40x24 mm bolt holes needs to be drilled into the concrete to be able to install 18 20mm bolts in a row welded under stanchion balustrade.

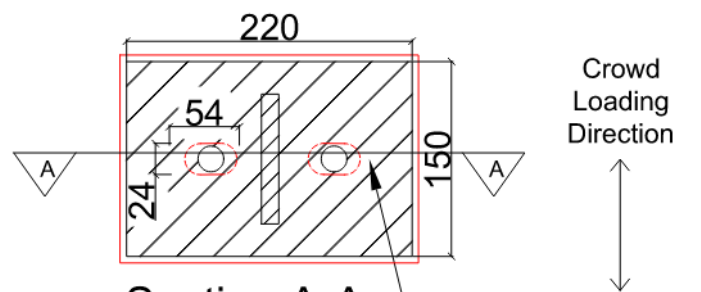
bolt fixing changed to epoxy stud fixing

Concrete Cut Plan View

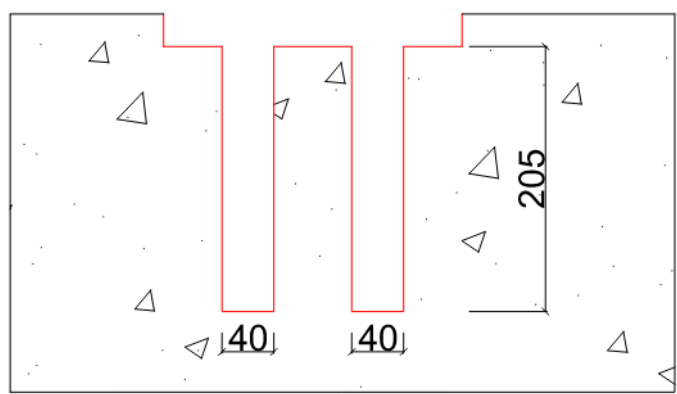
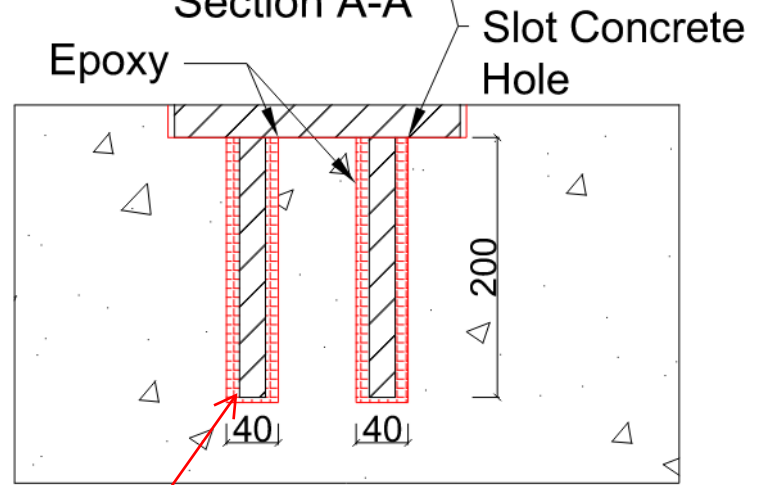
Do any Hilti epoxy fix product allow this type of application
